P802.3bs optical reflection limits

IEEE P802.3bs Task Force, SMF Ad Hoc, 16 August 2016

200GBASE-LR4 and 400GBASE-LR8

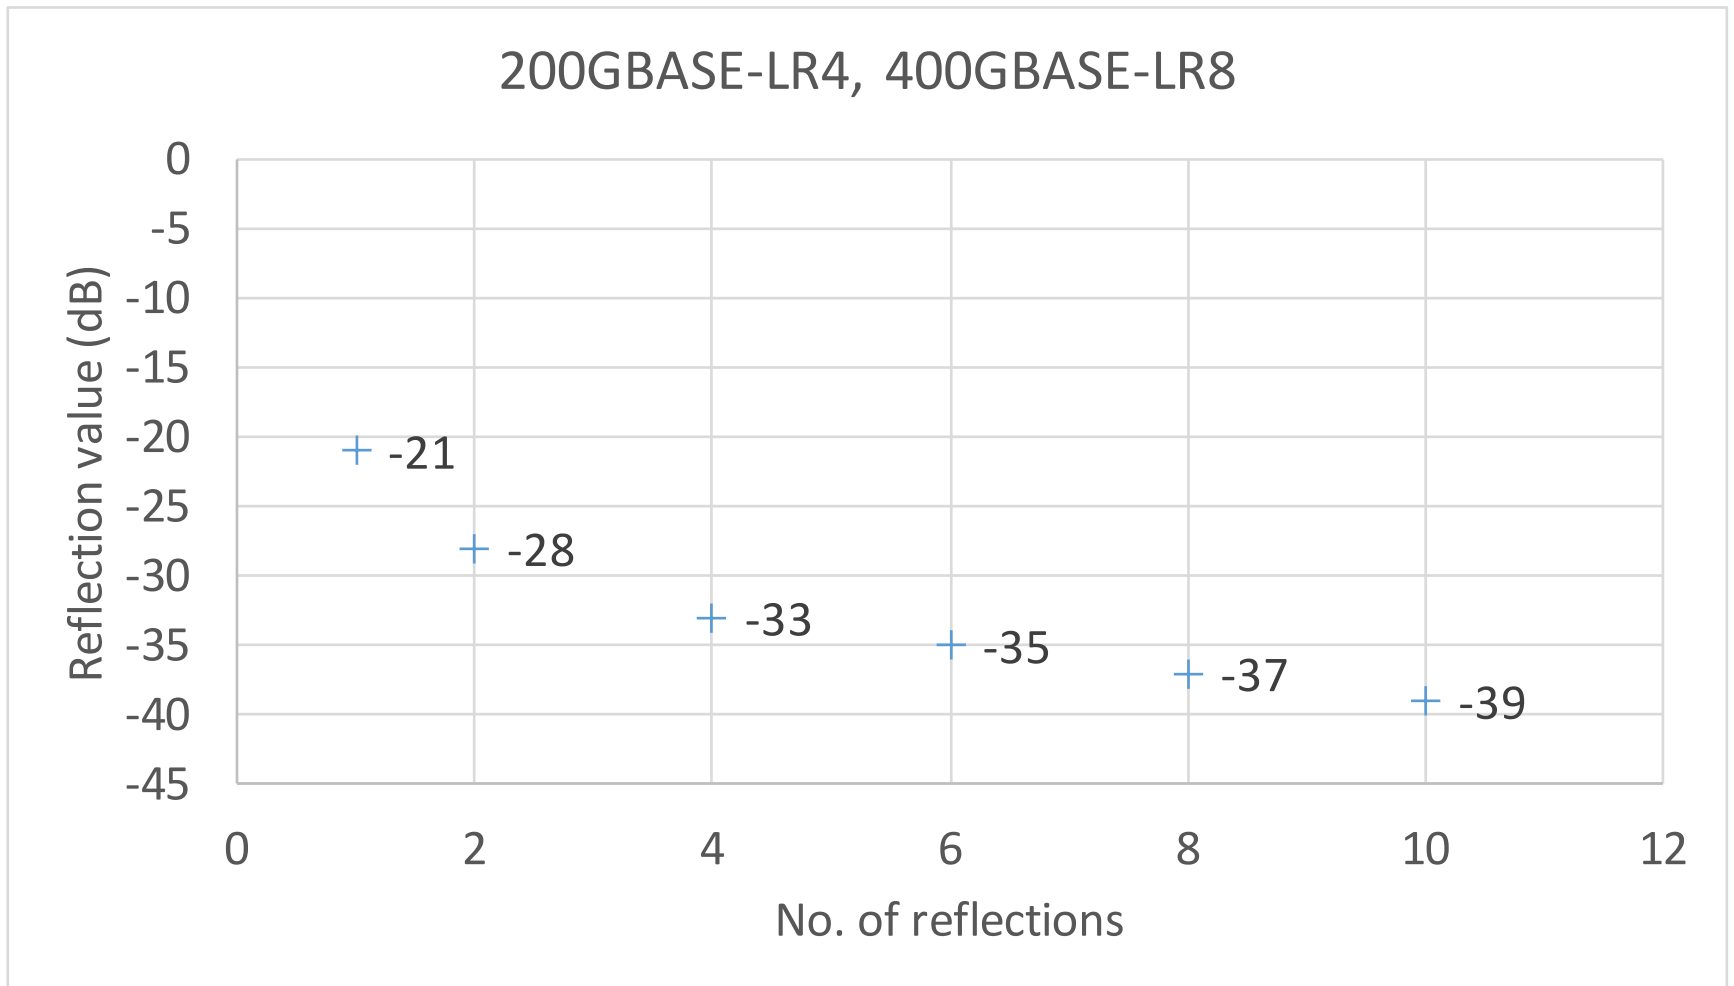
For example, 8 reflections of -36 dB seems to be allowed by the specification for 400GBASE-LR8, but may exceed the 0.5 dB MPI penalty allocation.

What about a smaller number of larger reflections? This could work satisfactorily, but is not currently allowed.

If the number of discrete reflectances above -60 dB is 4, each discrete reflectance shall be less than -35 dB. If the number of discrete reflectances above -60 dB is 8, each discrete reflectance shall be less than -40 dB.

200GBASE-FR4 and 400GBASE-FR8

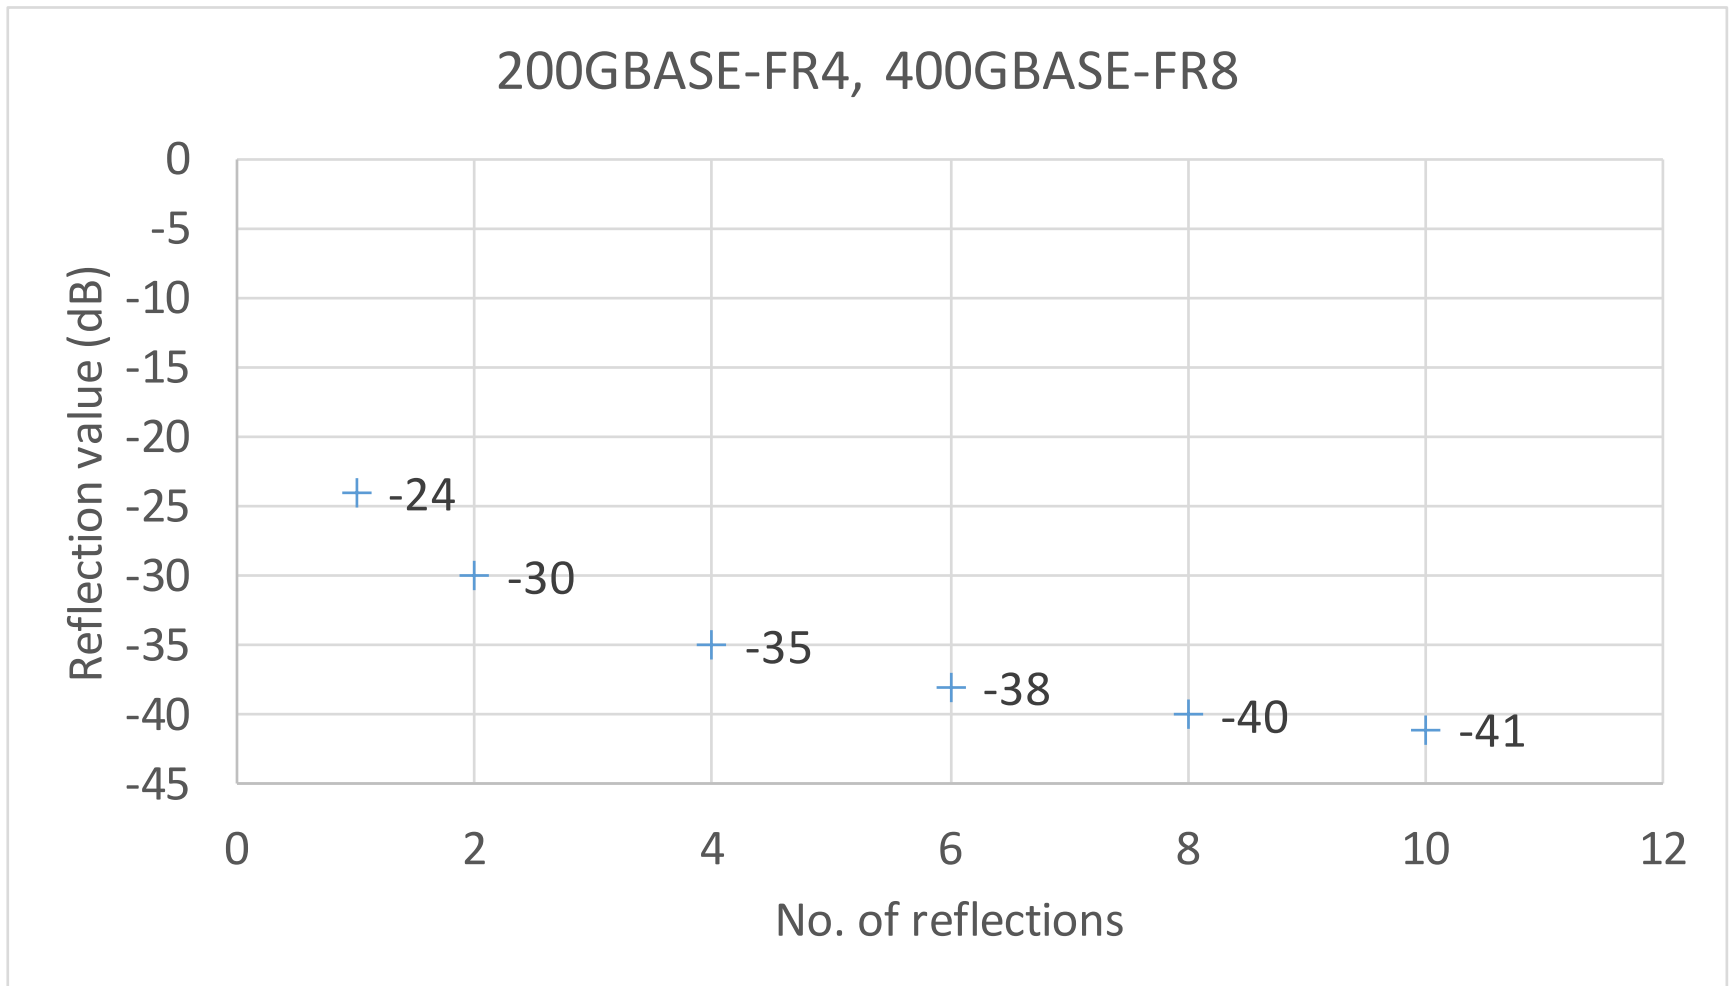
Is there any limit to the number of discrete reflections just below the -35 dB (or -45 dB) limit?
